Product Change Notice - Announcement

PCN no.: P25-2015-001
Date: 2015-04-27
PCN Type: Information
Subject: EGO[®] Radiant Heating Elements - omission of P1 tab
Reference: Product Management - Tilo Fucik

4. Identification of change

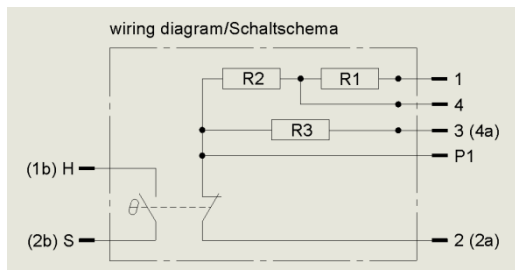
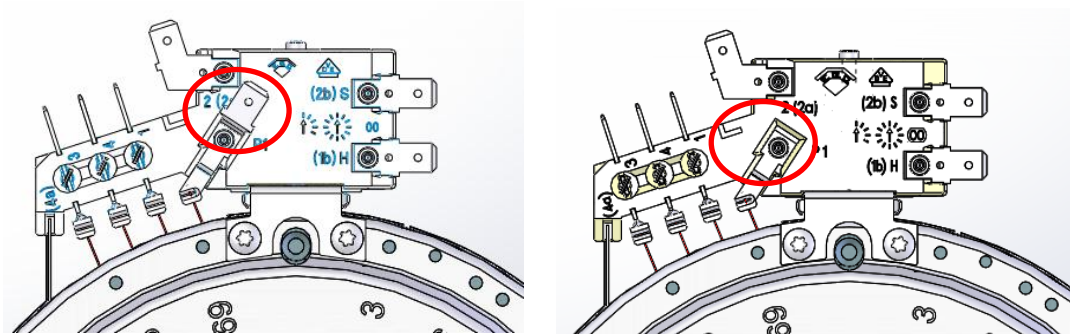
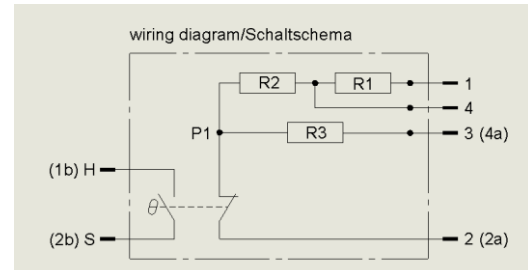
Continuous improvement of E.G.O.'s products and market observation has given the proof that the P1 tab on the below-mentioned EGO[®] types is not needed. Actually, the P1 terminal could even lead to failures or miswiring during the assembly of the heater in the hob.

The function of the limiter remains unchanged.

This change is made in order to help to increase the product quality within the hob production.

old version

new version
